CALL NO. 105
CONTRACT ID NO. 171035
ADDENDUM # 1

Subject: Boone County, STPM 5138 (066)
Letting September 29, 2017

- (1) Revised - Plans - R1, R2C, R2D, R7, R25, R42A
- (2) Revised - Bid Items - Pages 173-175 of 175

Boone County US 42 AT RICE PIKE STMP 5138 (066)

**US 42 AT RICE & HICKS PIKE
 MAINTENANCE OF TRAFFIC
 DETOUR SIGNAGE**

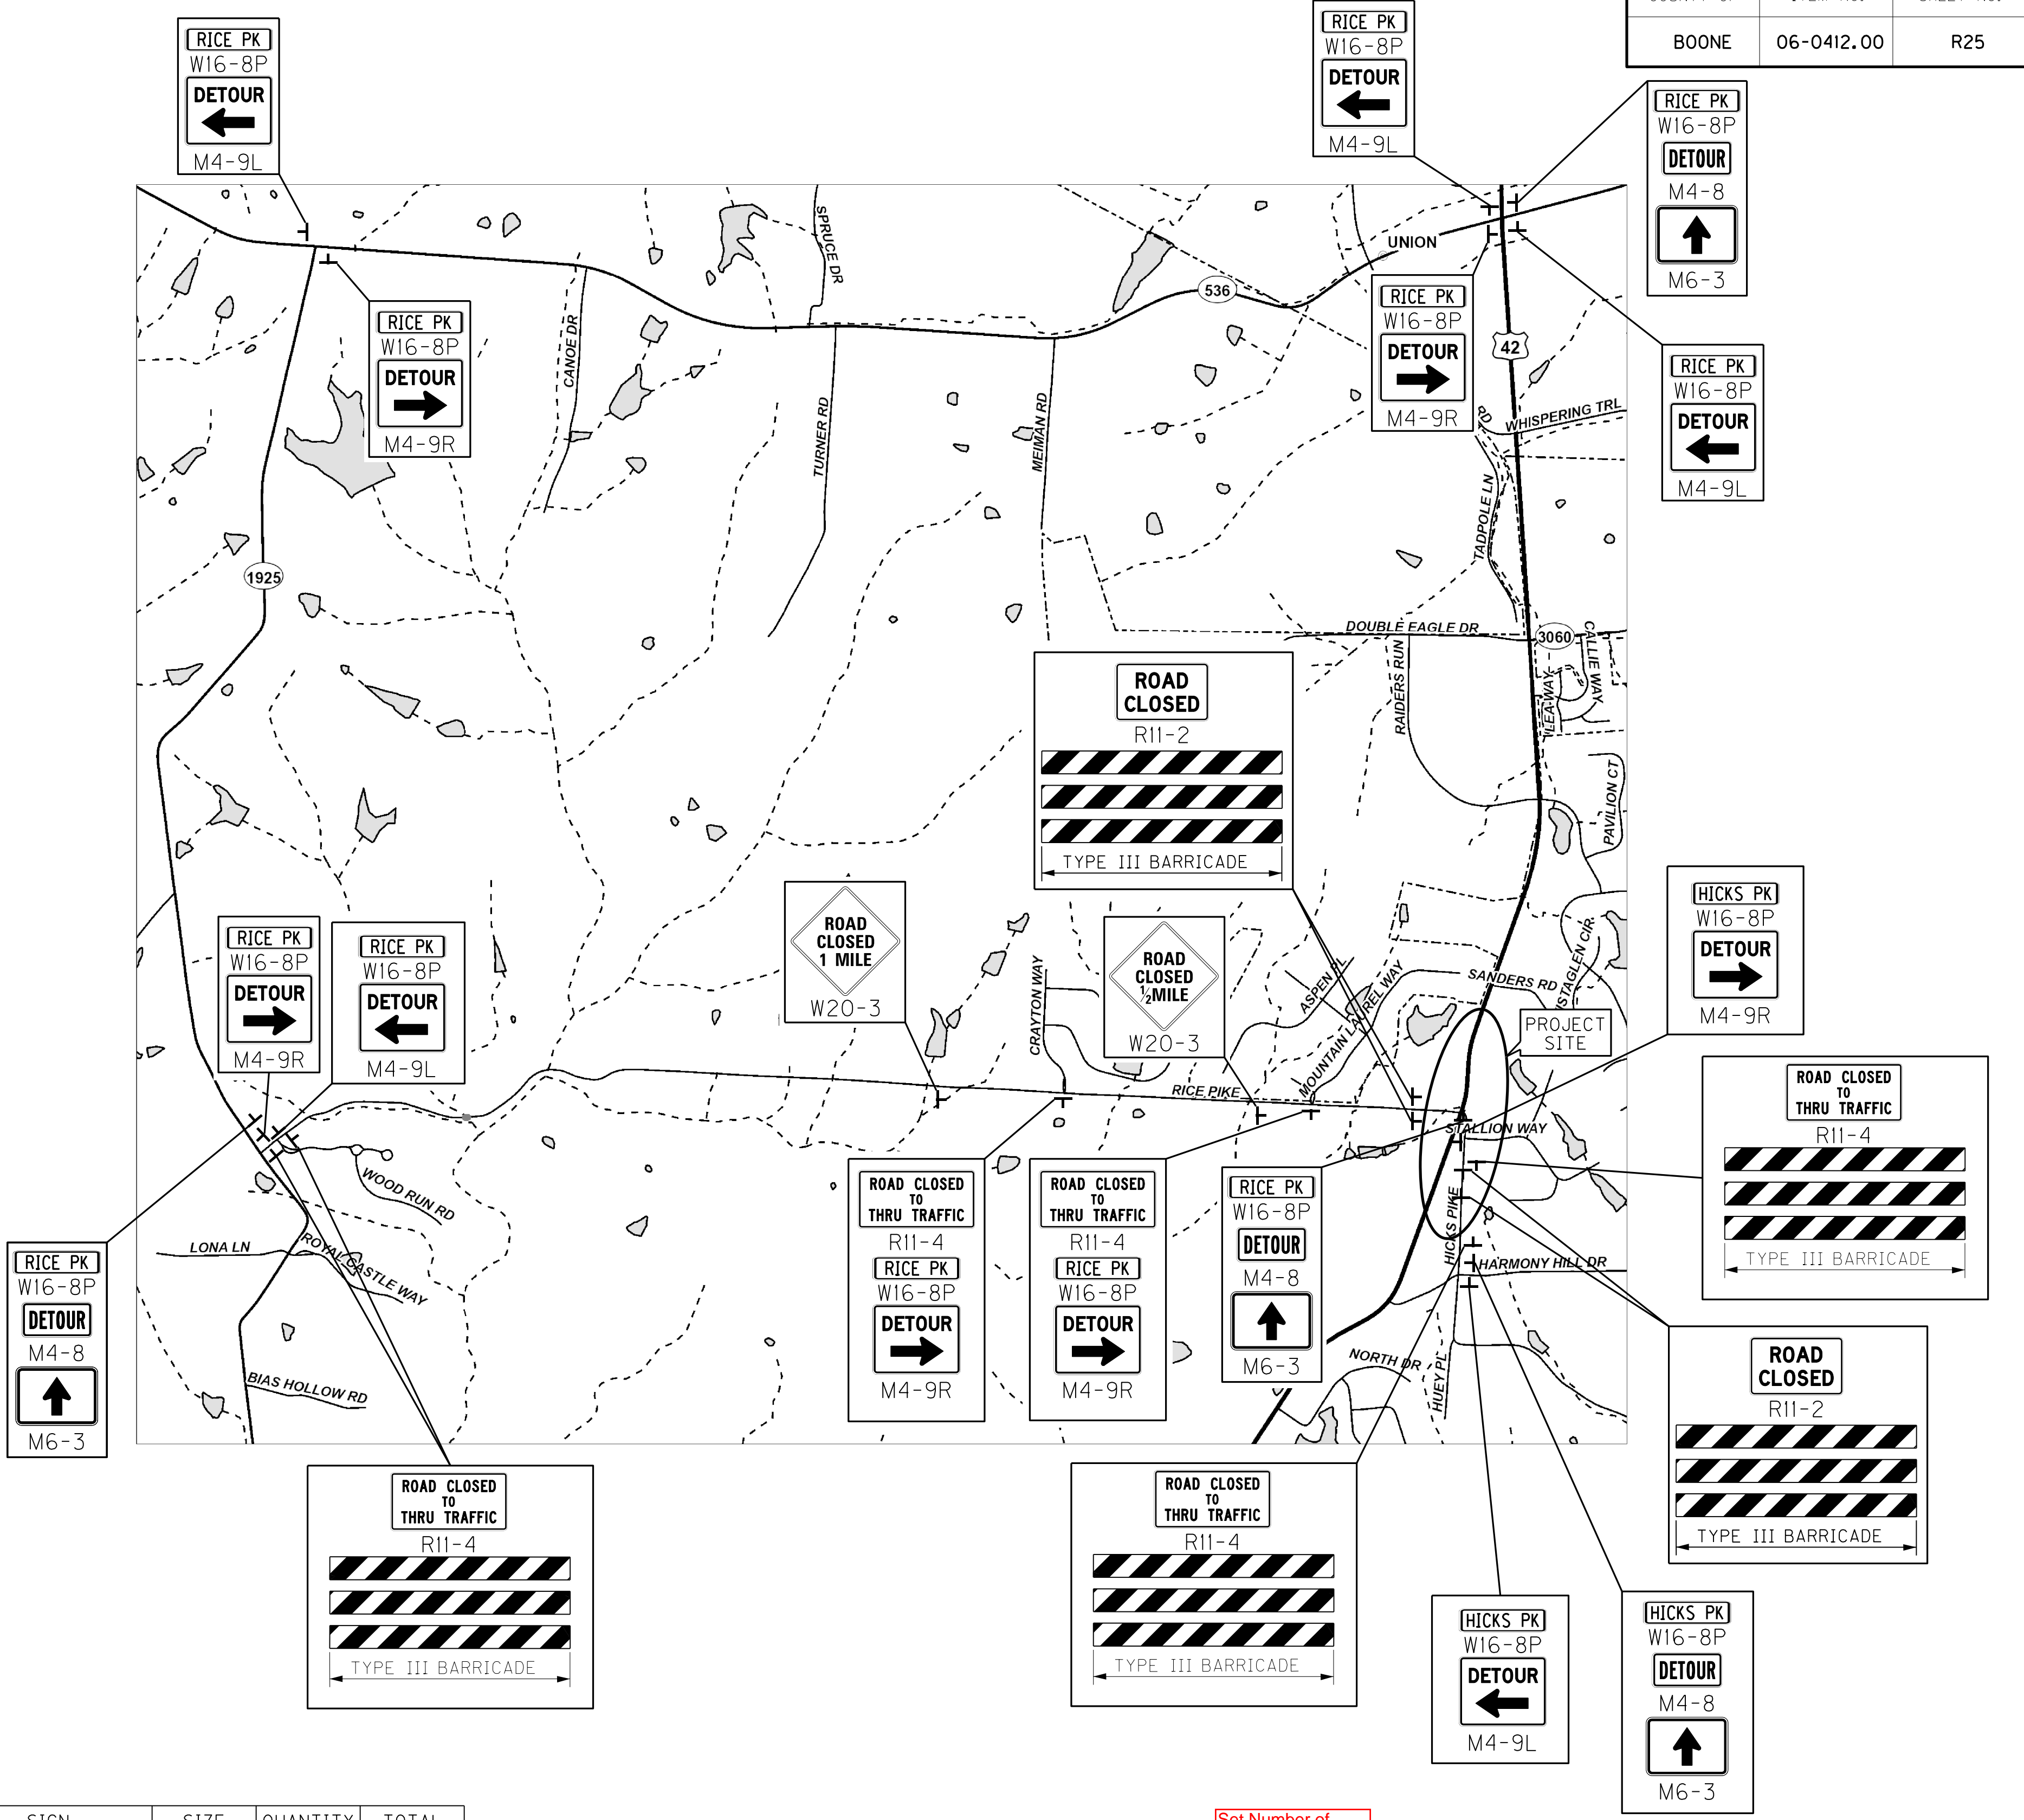
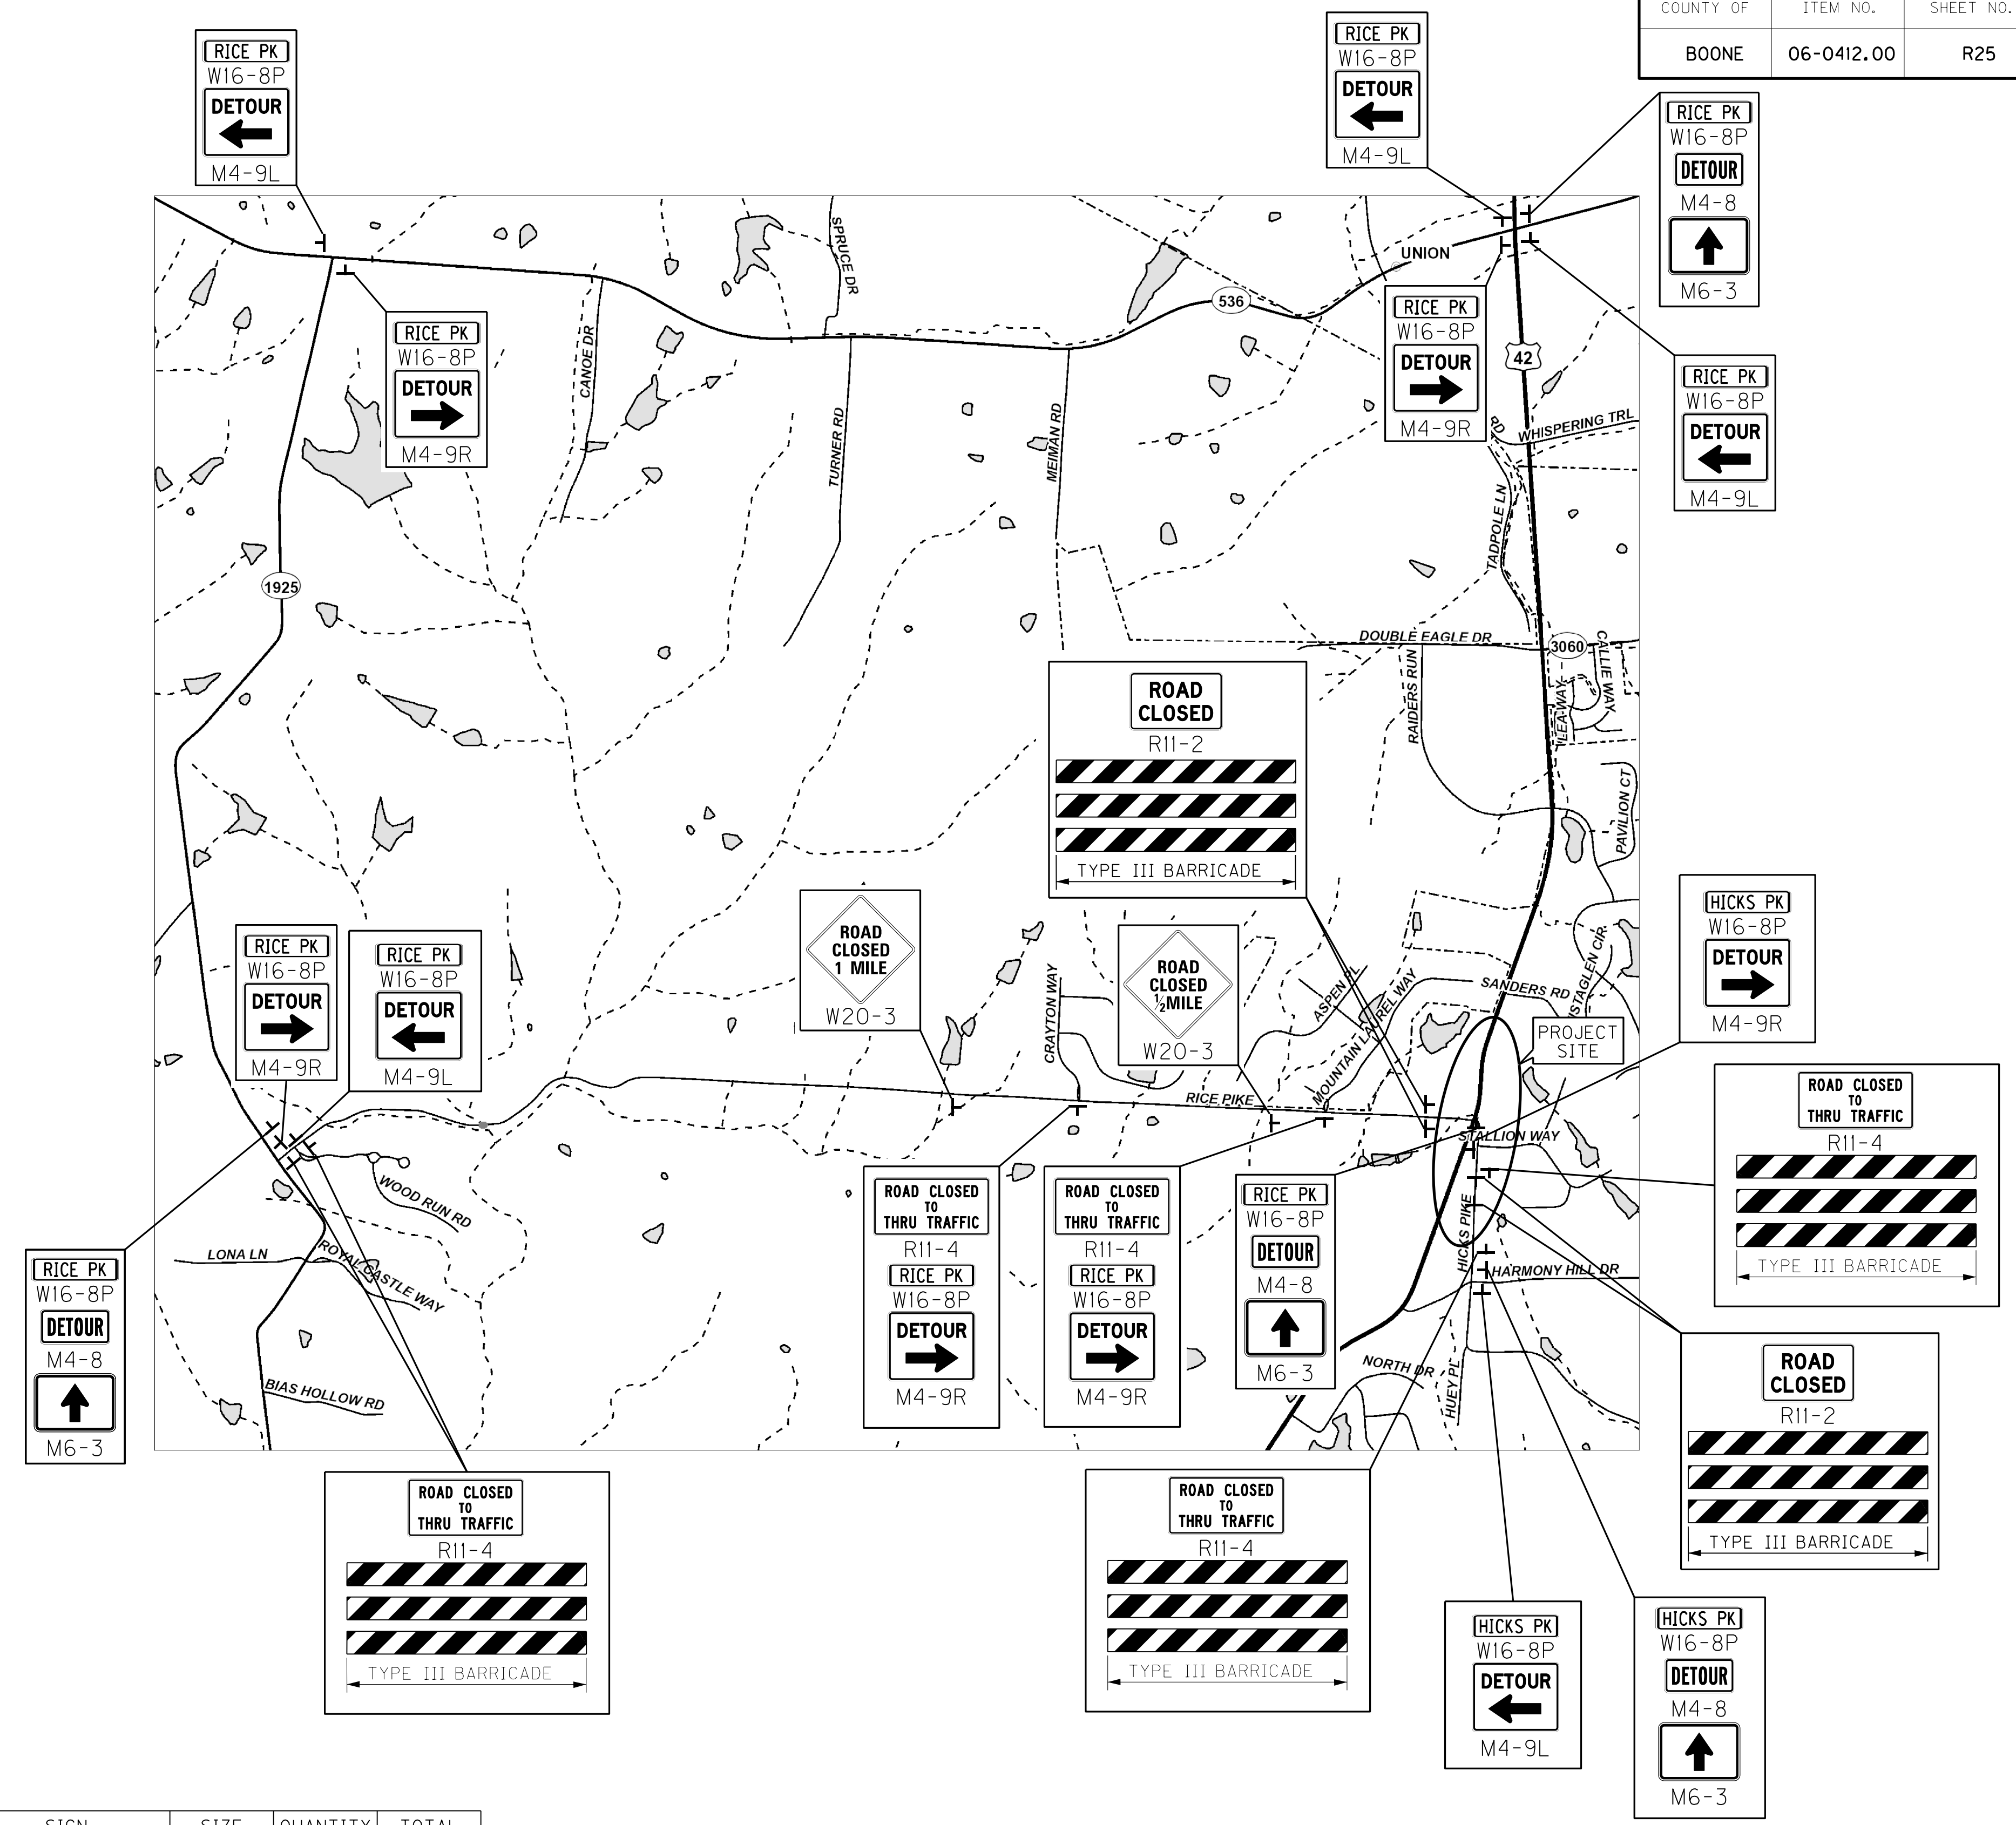
Set Number of Officers to One

LAW ENFORCEMENT OFFICERS
 POLICE SUPPORT SHALL BE A UNIT CONSISTING OF AN OFF-DUTY POLICEMAN FROM ANY POLICE FORCE AGENCY IN BOONE COUNTY, KENTUCKY AND A POLICE CAR EQUIPPED WITH FLASHING BLUE LIGHTS. IT IS ANTICIPATED THAT APPROXIMATELY ONE (1) OFFICERS WILL BE REQUIRED FOR EACH CLOSURE SET UP. THE OFFICERS WILL BE PLACED AT THE DISCRETION OF THE ENGINEER. POLICE SUPPORT WILL BE MEASURED AND PAID ON A PER HOUR BASIS FOR EACH OFFICER AND POLICE VEHICLE.
